# **Report to Committee**

RZ 04-266049

APPLICATION BY CENTURY HOLDINGS LTD. FOR REZONING AT 7571 AND

7611 ALDERBRIDGE WAY FROM LIMITED INDUSTRIAL RETAIL DISTRICT (14)

EAST ELEVATION SCALE: 1/16" = 1'-0"

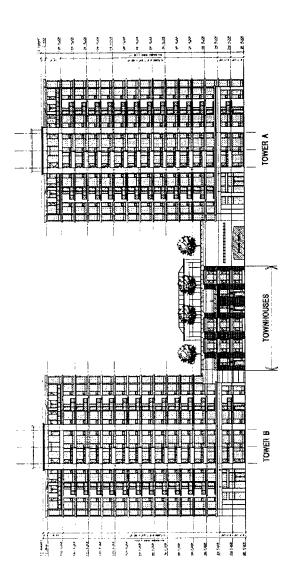
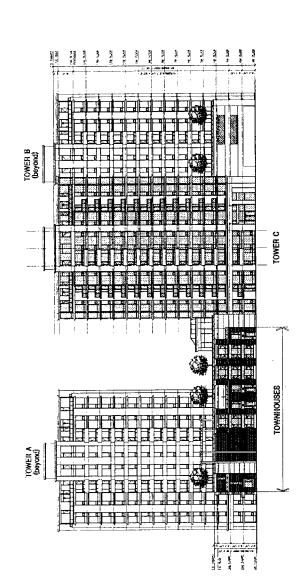
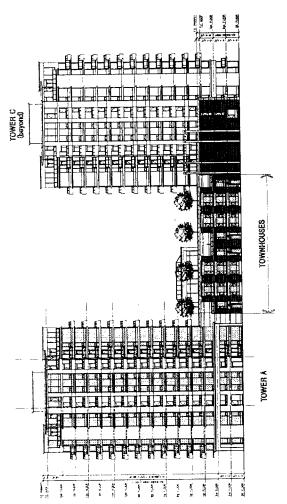
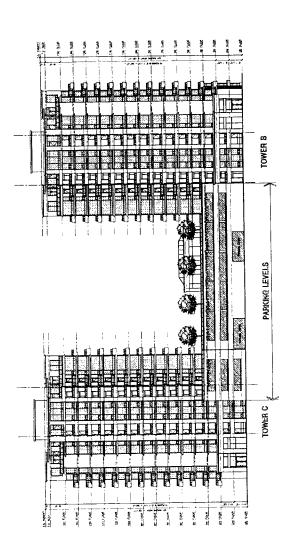
- Variations should be introduced into the design of the three towers to enhance the project's visual interest and the downtown skyline.
- With regard to form of development, the role of each of the three streets bordering the subject site and the rear lane are different and the design of the proposed building should respond to this and enhance it:

- The Gilbert frontage should be a combination of bold architectural features (i.e. attractive, glass-enclosed building lobbies, work/live units with a distinctive character, etc.), and generous landscaping (i.e. a double row of trees framing a 2.5 m/8.2 ft. min. wide sidewalk, decorative planting, water features, etc.) arranged to take advantage of Gilbert's curvilinear alignment that gives the street an informal feeling and provides for unusually sweeping views.

- Special attention should be paid to the prominent Lansdowne/Gilbert corner. Staff recommend that the
      design of this location, in particular, include a significant public art piece, as per Richmond's Public Art
      Program (e.g. valued at approximately \$0.60/ft² of buildable area), together with pedestrian weather
      protection, seating, and other amenities.

- b) Lansdowne -
    - Lansdowne will be a major east-west artery and an important greenway route linking the downtown with the riverfront.
    - The Lansdowne frontage should be more urban and formal than that along Gilbert, and should be designed to enhance the street's intended pedestrian role through the use of work/live units with individual entries along most of its length, opening onto a 2.5 m/8.2 ft. min. wide sidewalk lined with a double row of street trees, and framed by the afore mentioned public art feature at Gilbert and an attractive, glass-enclosed building lobby at Alderbridge. Pedestrian weather protection is encouraged.

- c) Alderbridge
    - o Alderbridge will be similar to Lansdowne in its role and prominence, but its character should be somewhat more urban.
    - O As for Lansdowne, work/live units are encouraged along most of the length of the Alderbridge facade, framed by building lobbies at corners, and opening onto a 2.5 m min. wide sidewalk lined with a double row of trees. The work/live units should, however, have a more urban character. Preferably, this should include more hard landscaping along the street front, little if any private outdoor areas at grade, and continuous pedestrian weather protection.

- The gate on the parking garage entry on Alderbridge should be recessed at least 15 m (49 ft.) from the property line to minimize queuing across the sidewalk.

- The building frontage along the lane should incorporate CPTED principles, attractive and durable
      materials, green landscaping, and other measures that will enhance pedestrian amenity and visual
      interest. In addition, planting, landscape features, and special paving treatments should be incorporated
      into the proposed turn-around to enhance its appearance.
